Schneider Electric Xantrex™ XW Software Release Notes

975-0604-01-01
Revision A

Figure 1 Xantrex XW-MPPT60-150 Charge State Diagram

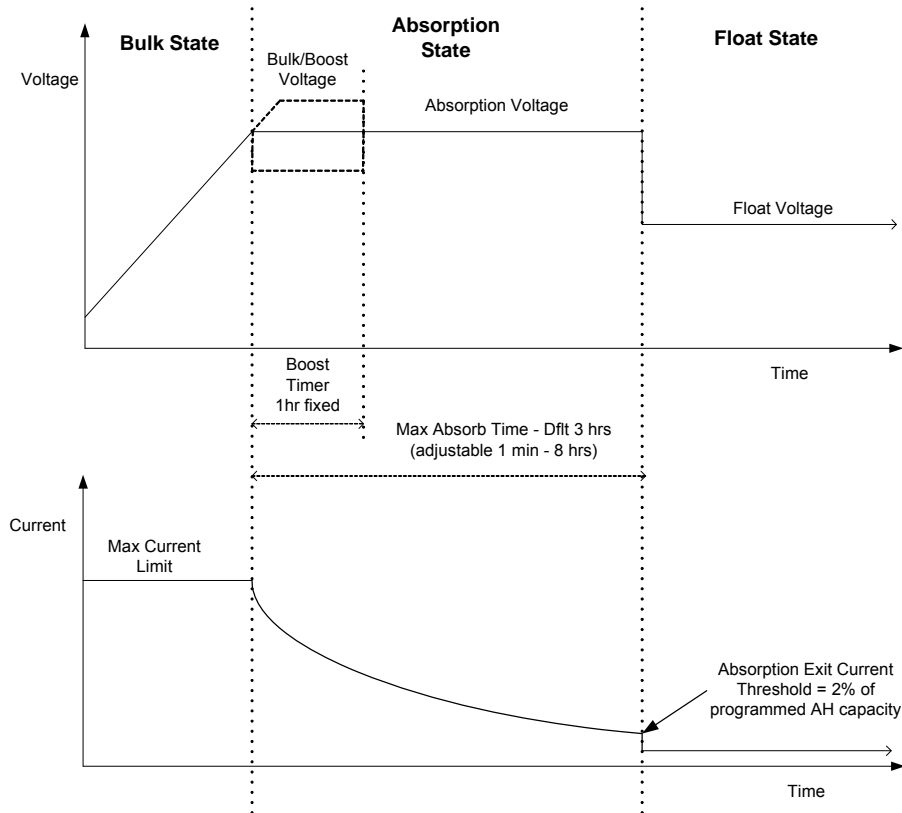
1. The charge algorithm was modified. See the accompanying diagram that shows precisely how the algorithm operates now:
